Dentistry — Coupling dimensions for handpiece connectors

AMENDMENT 1

STANDARDSISO.COM : Click to view the full PDF of ISO 3964:2016/Amd 1:2018

Figure 5

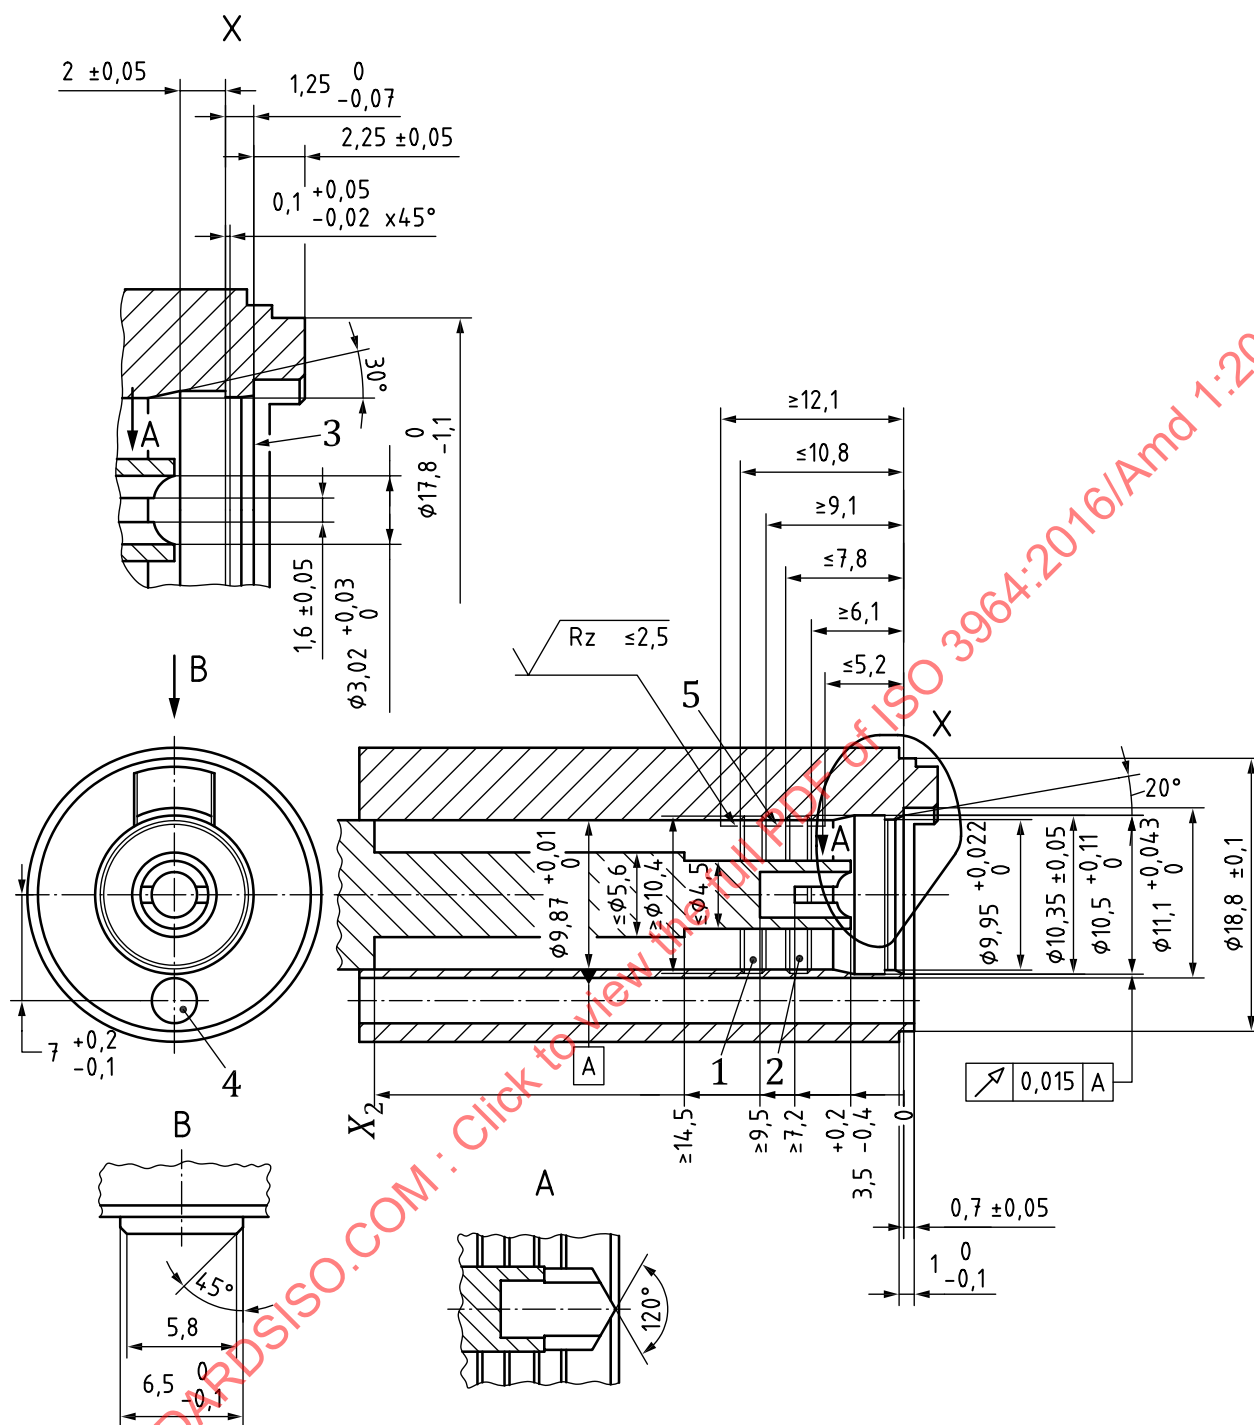
Replace the tolerance for dimension " $\varnothing 18,8 \begin{smallmatrix} 0 \\ -0,1 \end{smallmatrix}$ " with " $\varnothing 18,8 \pm 0,1$ ".

Replace the tolerance for dimension " $\varnothing 17,8 \begin{smallmatrix} 0 \\ -0,1 \end{smallmatrix}$ " with " $\varnothing 17,8 \begin{smallmatrix} 0 \\ -1,1 \end{smallmatrix}$ ".

Replace the tolerance for dimension " $\geq 10,8$ " with " $\leq 10,8$ ".

Replace the tolerance for dimension " $\geq 7,8$ " with " $\leq 7,8$ ".

Replace the tolerance for dimension " $\leq 6,1$ " with " $\geq 6,1$ ".

Replace Figure 5 with the following Figure:

Figure 6

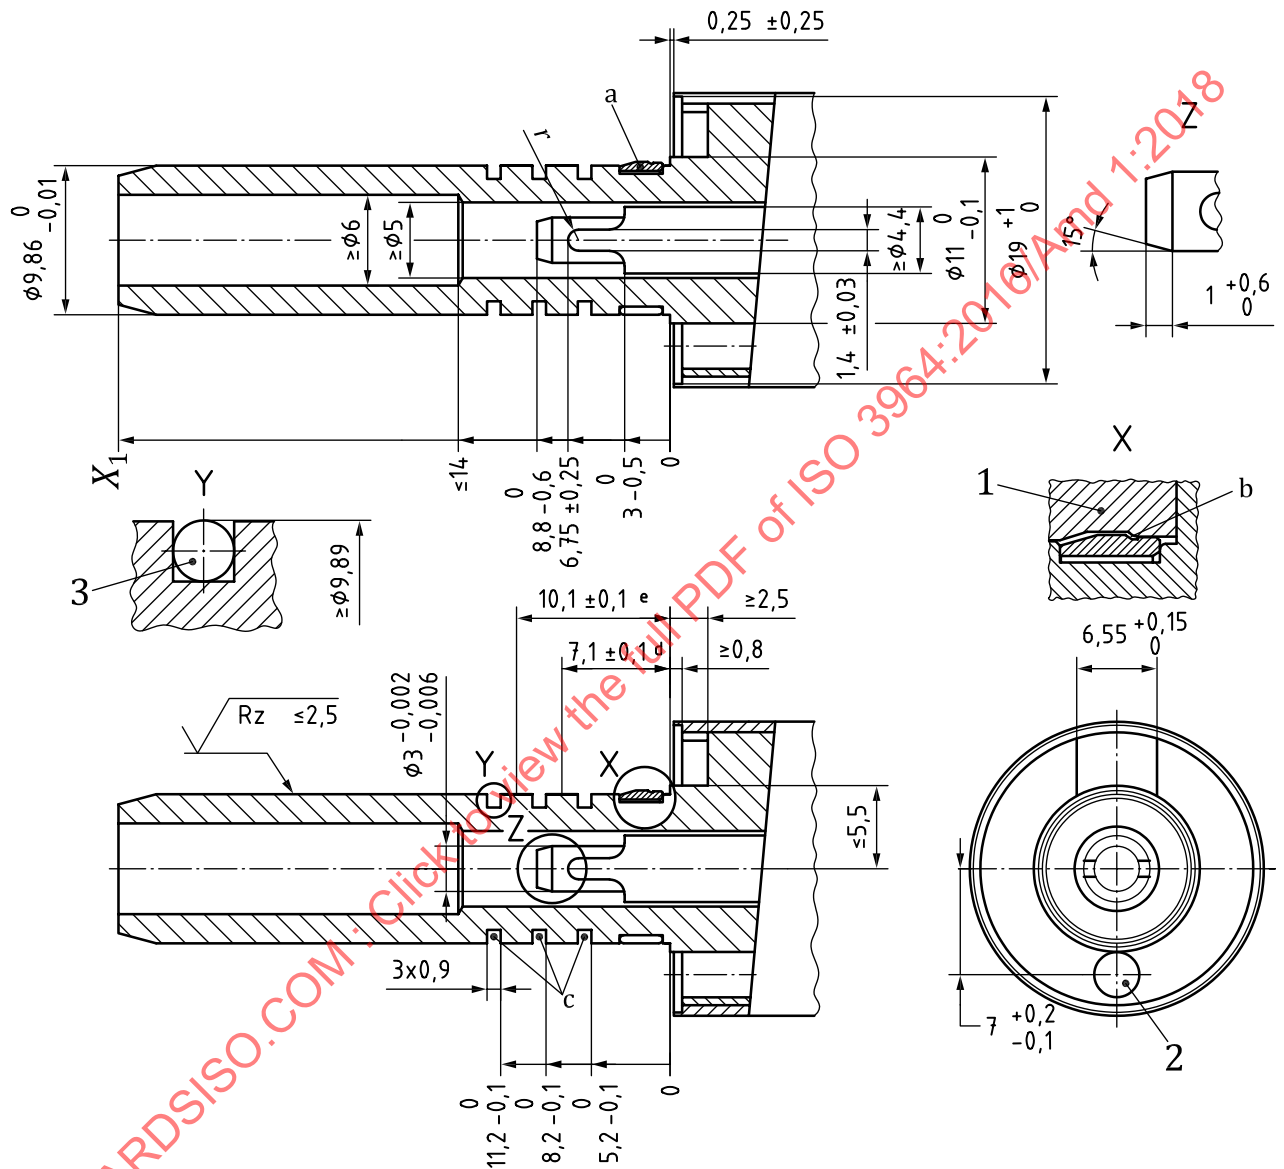
Correct error in the upper and lower part of drawing, left section, right side for the motor body.

Replace Figure 6 with the following Figure:
